YOR920030479US1 Serial No. 10/717,737

AMENDMENTS TO THE DRAWINGS:

FIG. 3J

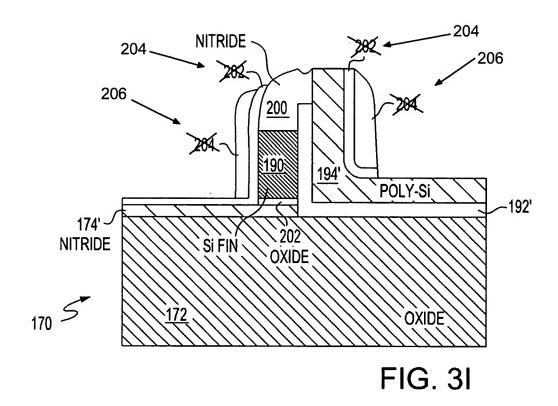
Figure 3K is objected to because "202" designates two different elements. Upon review of Figure 3K, applicants noticed that one instance of 202 had, inadvertently, labeled the "thin gate dielectric 204" as described in paragraph 0027. Applicants also noticed that this typographical error in Figure 3K was also included in Figures 3I and J. Further, applicants noted that "polysilicon spacers 206" had been inadvertently labeled 204 in Figure 3I. Accordingly, replacement sheets including Figures 3I – K are included herewith. Annotated sheets showing changes follow the replacement sheets. Reconsideration and withdrawal of the objection to the drawings is respectfully solicited.

The attached two (2) sheets of drawings include changes to Figures 3I – K. These 2 sheet, which include Figures 3I – K, replace the original sheets 12 and 13 including Figures 3I – K. Two (2) annotated sheets showing changes follow the replacement sheets.
